Plan Change Request

Project Information PCR 002

➤ Specify the approved civil plans affected: Sheet C15 - North Utility Yard Infiltration Pond

NORTH UTILITY YARD INFILTRATION POND FOR CENTERIS VOLTAGE PARK

Title: **NORTH UTILITY YARD INFILTRATION POND**
CENTERIS VOLTAGE PARK

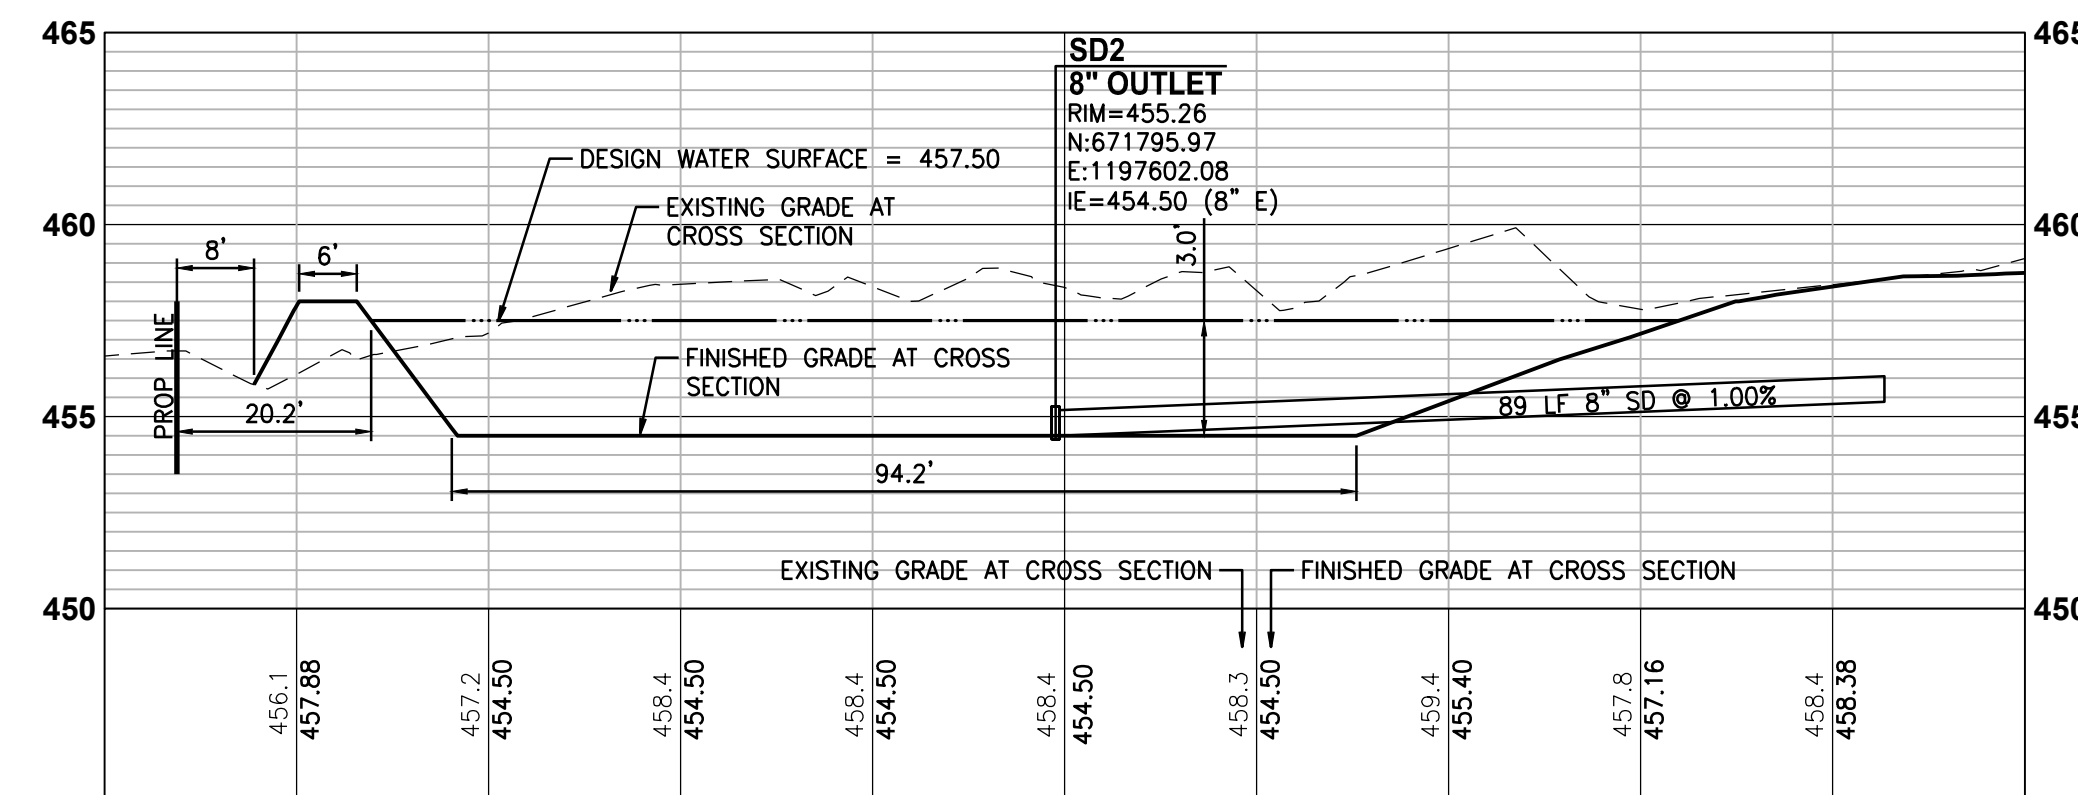
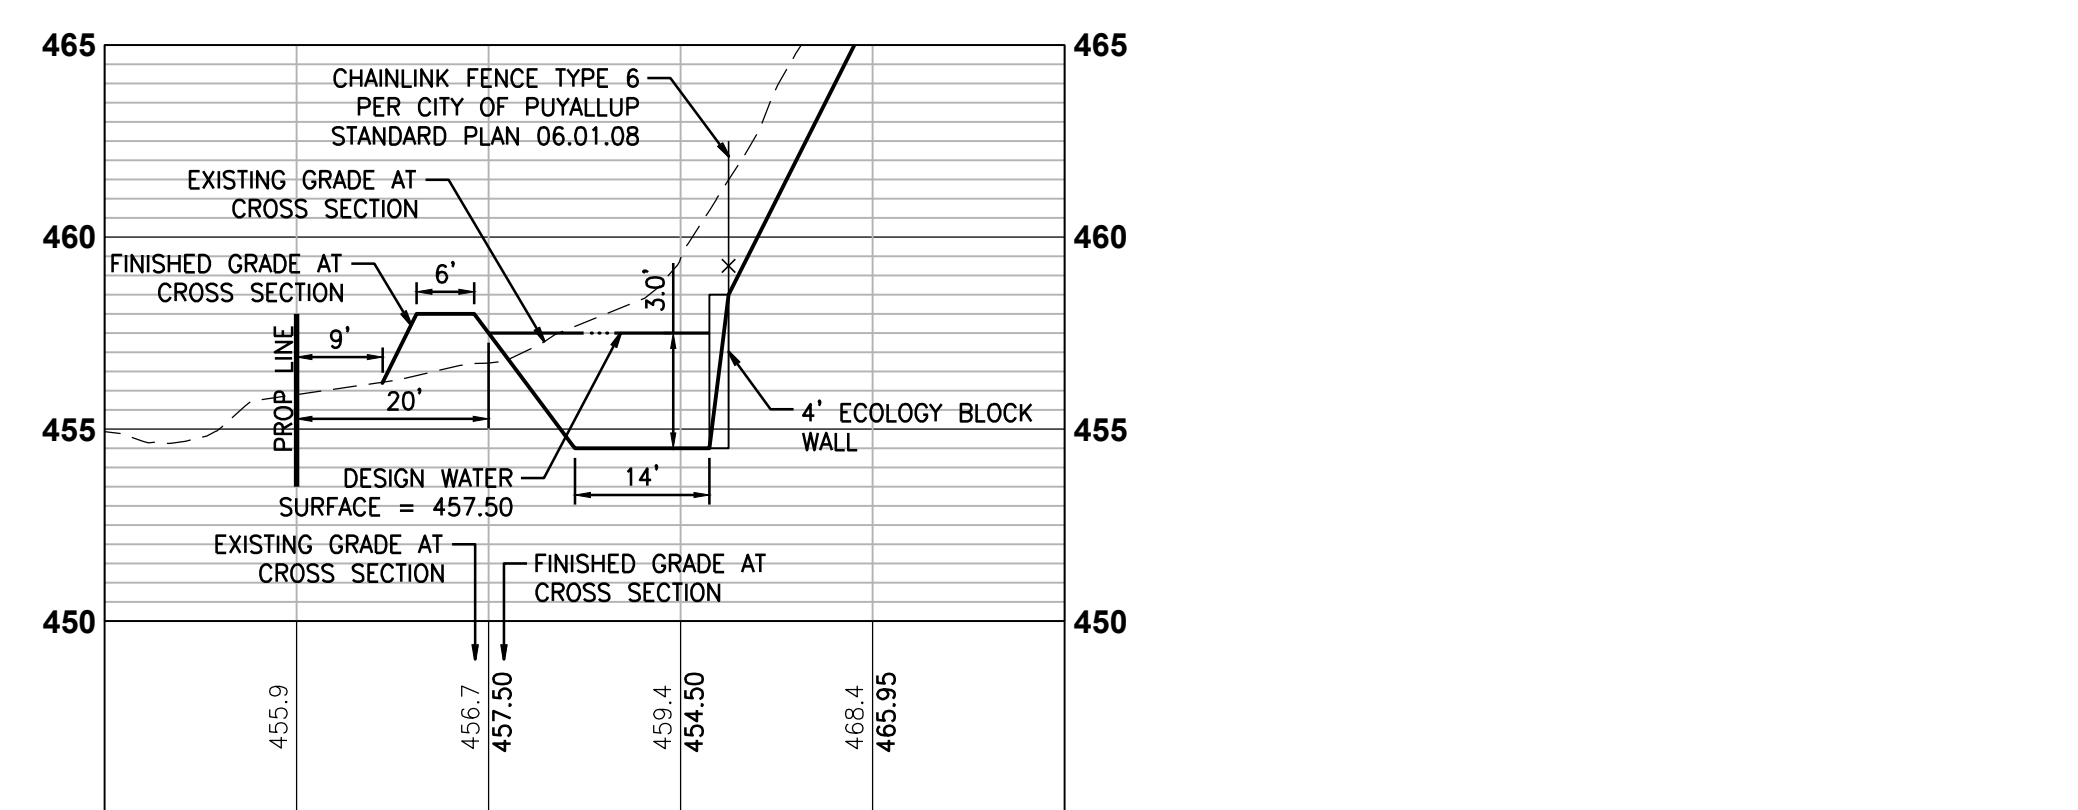
➤ Describe the change(s) being requested:
Retaining wall addition between the pond access road and the south side of the wetland to reduce the slope and ensure grades are met outside of the wetland.

No.	Date	By	Cd.	Appr.	Revision
10	1/22/25	KDM	CMV	CMV	NORTH POND WALL ADDITION
9	12/13/24	KDM	CMV	CMV	CITY COMMENTS ON SOUTH YARD
8	10/25/24	KDM	CMV	CMV	SOUTH UTILITY YARD AND NORTH POND REVISIONS

Separate Building Permit required due to surcharge. Include additional wall as an amendment to BP PRRWF20241913 or apply for separate building permit.
